GGG-F-00340(GSA-FSS)
AMENDMENT-2
October 6, 1970
SUPERSEDING
Interim Amendment-1
February 9, 1970

AMENDMENT

INTERIM FEDERAL SPECIFICATION

FILES, ROTARY

FIGURE 9 Tooth Design

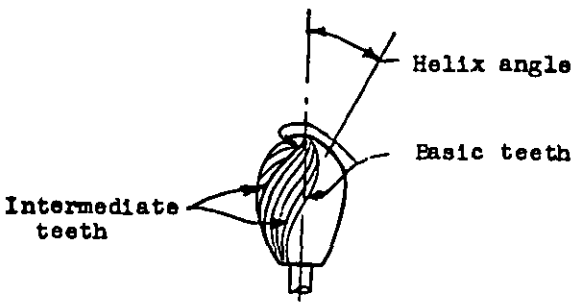
Add new paragraph 3.5.1 as follows:

3.5.1 Types I, II, III, V, VI, and VII. The teeth of the types I, II, III, V, VI, and VII files shall be similar to those shown in figure 9. The number of basic teeth shall be 6, plus or minus 2 teeth, and shall extend from the base to the nose of the cutting head. The intermediate teeth, located between the basic teeth, shall extend from the base of the cutting head and terminate at the basic teeth.
